Summary of Submissions:

The tables below summarise the comments received during the advertising period of the proposal, together with the Applicant's response to each comment.

Site plan/shadow diagram. Orange shading indicates existing overshadowing, predominantly caused by 2.3m high brick rendered wall contained within Lot 116. Proposed overshadowing in blue shows it'll mostly overlap with existing shadow, or cast over the roof of adjoining dwelling on Lot 116.

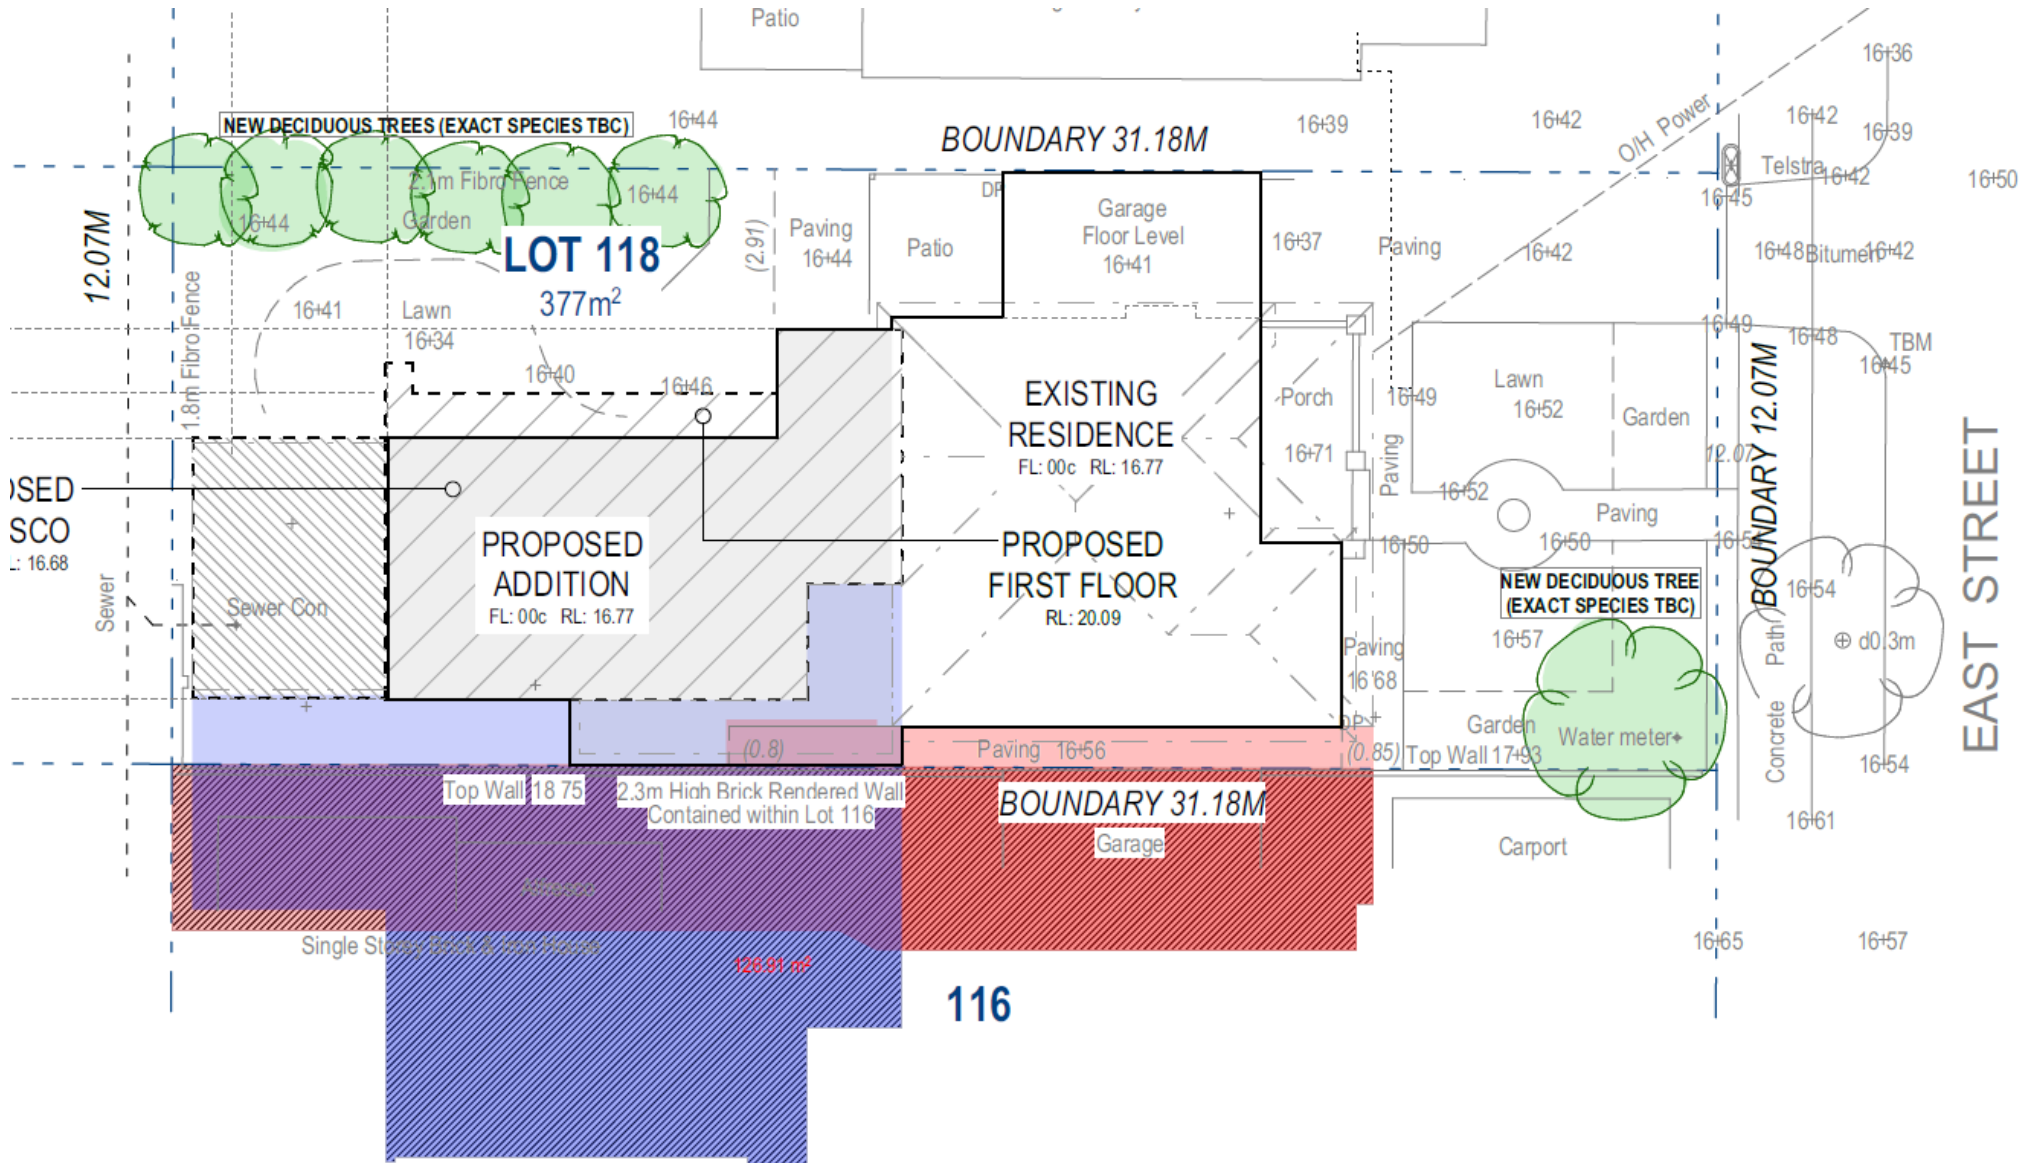
Comments Received in Objection:	Applicant Comment:
<p><u>Open Space</u></p> <ul style="list-style-type: none"> The lack of open space reduces the ability for future landscaping and planting 	<ul style="list-style-type: none"> Site coverage is compliant with R-codes and LPS. Tree planting proposed along Northern boundary, as well as within front setback. Proposal achieves over 60% open space, that is 15% more than the minimum 45% required by the Residential Codes of WA, Table 1.
<p><u>Lot Boundary Setbacks</u></p> <ul style="list-style-type: none"> The building bulk of the development encroaches onto other properties The two-storey box design is significantly imposing to single story homes adjacent The reduced setbacks result in loss of sunlight to adjoining properties as well as reduced ventilation The reduced setbacks affect the outlook from the neighbouring backyards and windows Boundary wall heights will provide building bulk impacts to adjoining properties and reduce sunlight The reduced setbacks will set a negative precedence for future developments in the area. 	<ul style="list-style-type: none"> South-elevation has been amended with increased setback and more articulation following comments from DRP chair and meeting with Scout Walsh. As demonstrated on shadow diagram, existing boundary wall on adjoining lot 116 already overshadows the courtyard. Height and setback of the 2-storey element are compliant. The element that constitutes "reduced setback" only refers to the lower portion of the wall, which is almost completely screened by the boundary wall on the adjoining lot. The upper floor portion is fully compliant. This is outlined and discussed in the letter of justification included in our initial submission. Please refer to shadow diagram and photographs included on the last few pages.
